COLLINSWOERMAN | TALON | KIRKLAND PARKPLACE | OCTOBER 5, 2015

DESIGN CONCEPT - BUILDING E

Design Review Board Direction at Design Response Conference (8/17/2015)

DETAIL ELEVATION NORTH FACADE

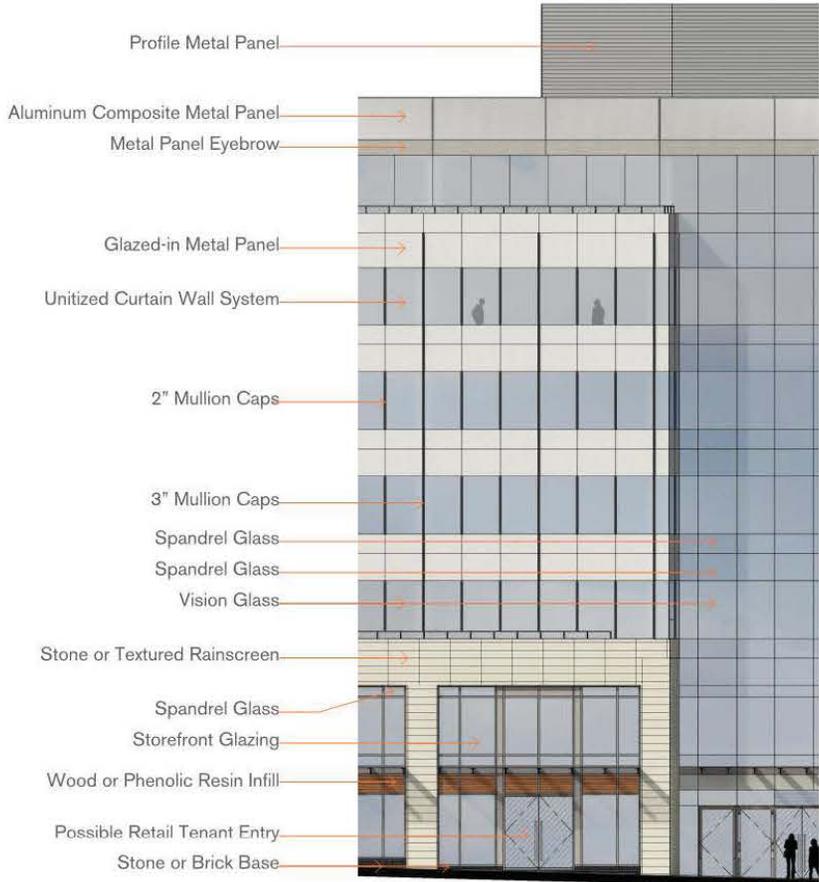
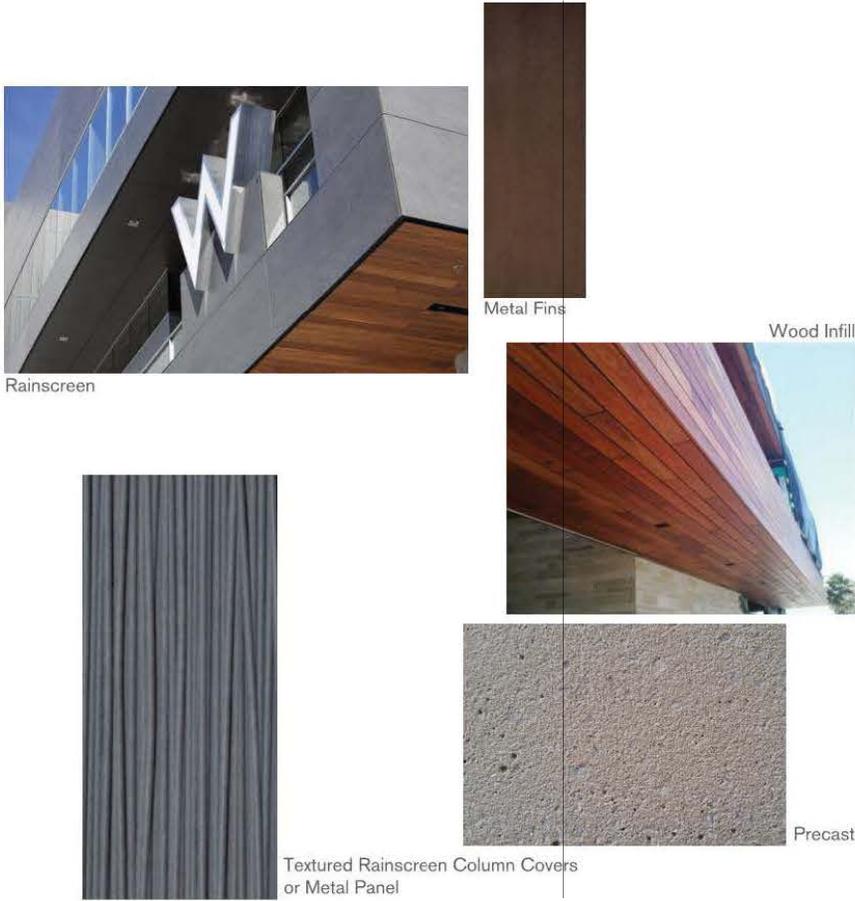
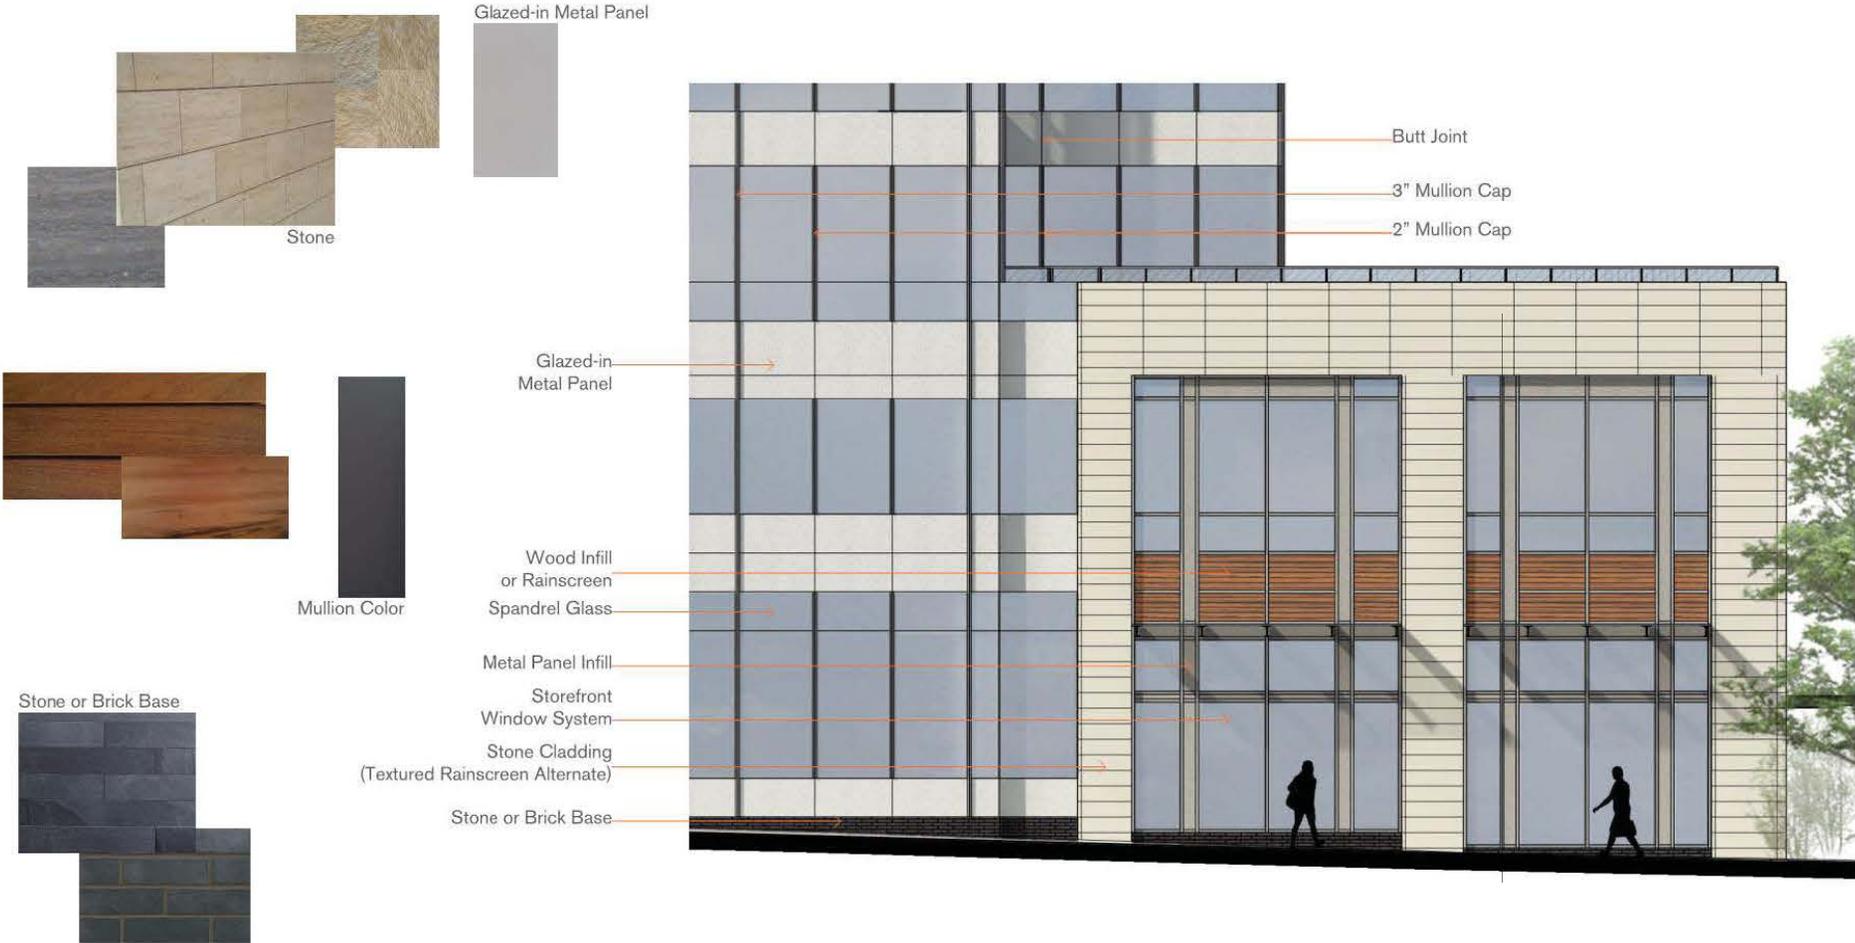
B. CENTRAL WAY FACADE

- Western portion of the façade appears long
- Punched opening façade needs refinement
 - Interface with base needs to be stronger
 - North west corner of tower – brick return needs to be refined
- Overall façade needs refinement and additional detail
- Explore ways to break down scale further
- Provide additional detail at the base of the building

- The west portion of the Central Way façade is now broken into multiple sections to reduce the apparent length and better define the base from the upper stories.

- The punched opening expression has been eliminated and replaced with a window wall and rain screen expression that is contained within a perimeter frame of precast concrete (or cement composite rain screen).

- Vertical fins at 15 feet on center break up the façade and decrease the apparent length.
- The base below this portion of the façade consists of pilasters with storefront infill.

- To the west of this element, a bay of the unitized curtain-wall façade from the upper levels is allowed to extend to grade, providing a visual break in the façade between the frame and pilaster element and the adjoining retail façade to the west.

- Additional detail has been added to the street level façade, including articulation of the bays with thickened verticals and the addition of a wood or wood look horizontal band, and a base treatment of stone or brick at the bottom of the retail storefront.

- The preferred material at the solid sections of the building base will be either stone or Takl rainscreen.

DETAIL ELEVATION SOUTH FACADE

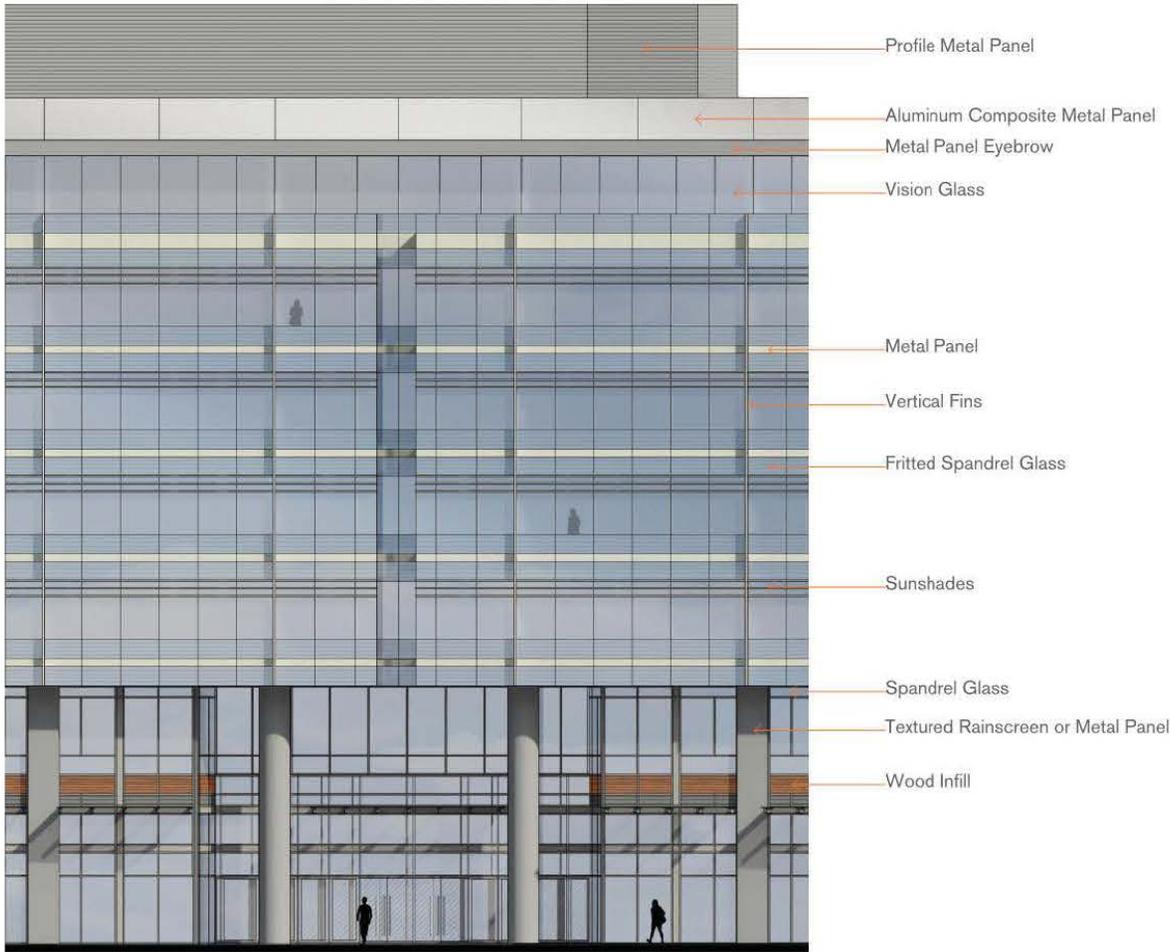
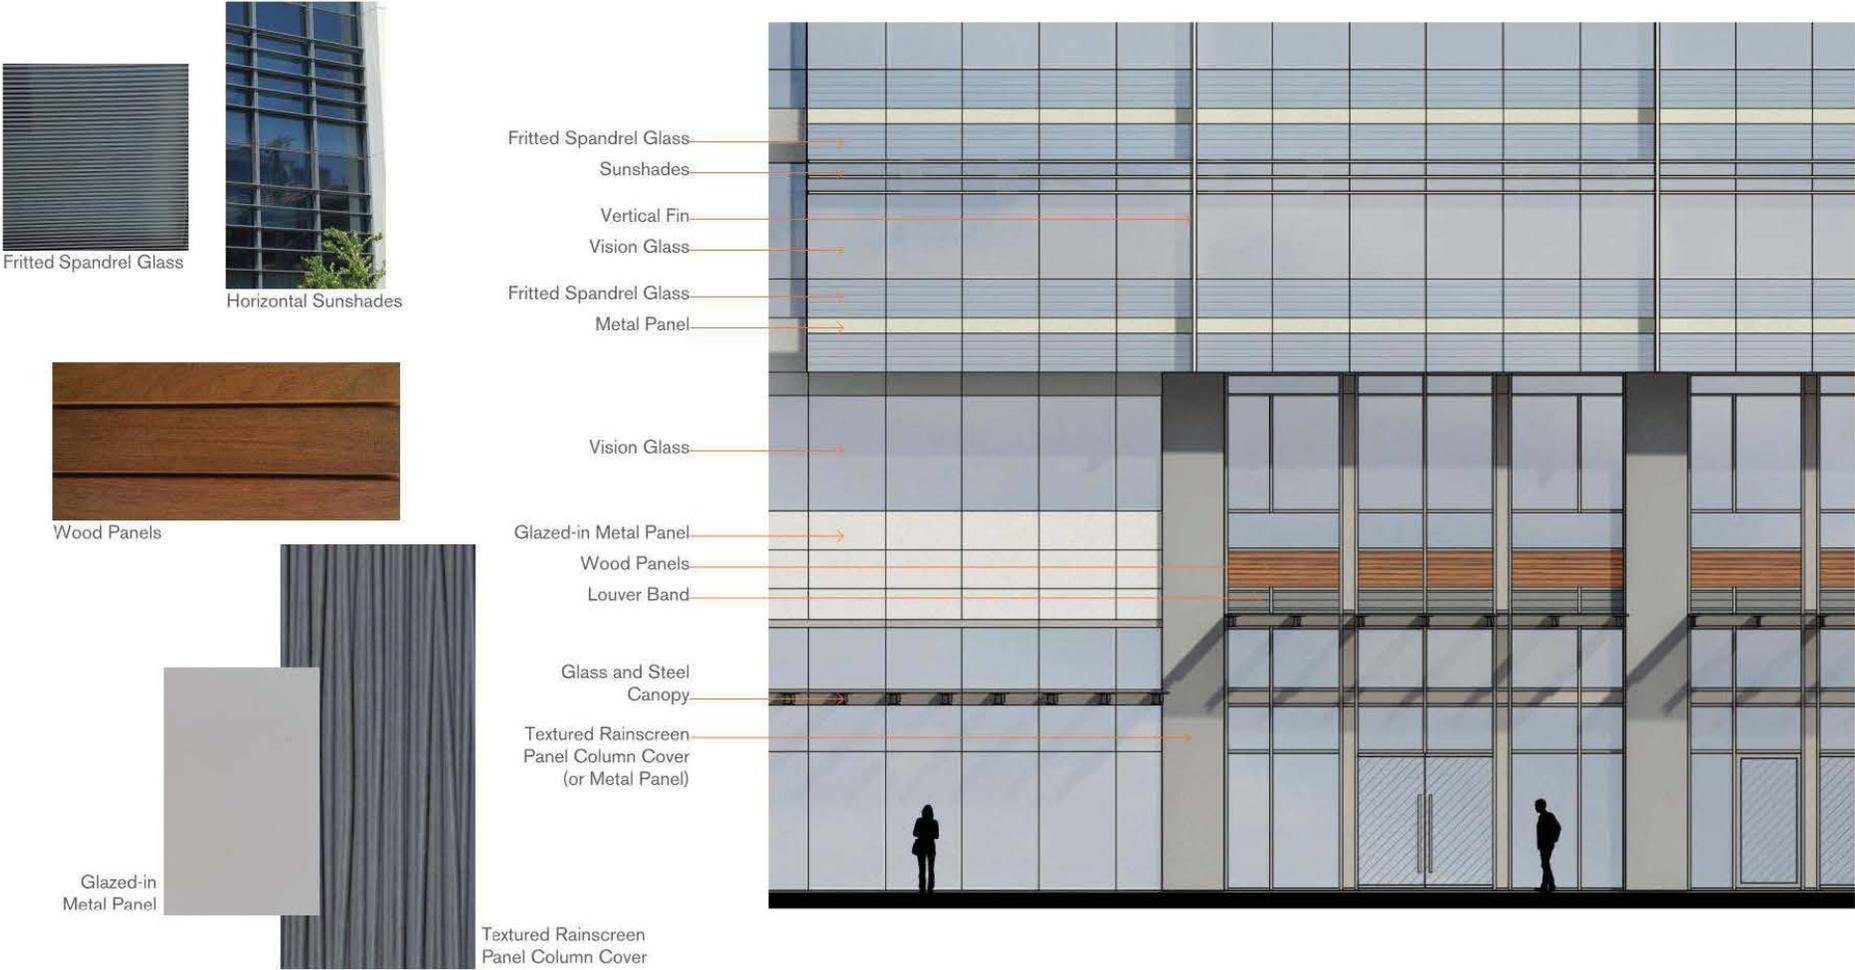
A. CURVED FACADE AT SOUTH ELEVATION

Explore ways to break down the scale and/or provide more detail

- Appears too long and unbroken
- Investigate elements to provide a visual cue to denote the building entry
- Overhangs appear to reinforce length

- The curved facade has been shortened by 10 feet on each end, resulting in a 20 foot shorter element. A notch has been added to the facade, aligning with the building entry. This break in the facade divides the elevation into two unequal segments and provides a visual clue to mark the entry to the building central space.
- In addition, vertical fins have been added at the column lines and the horizontal sunshade is split into two or three segments that are approximately 12 inches deep. Both elements provide shade and shadow to the façade and break up the elevation into smaller components while allowing the strong gesture of the curved wall to read through.
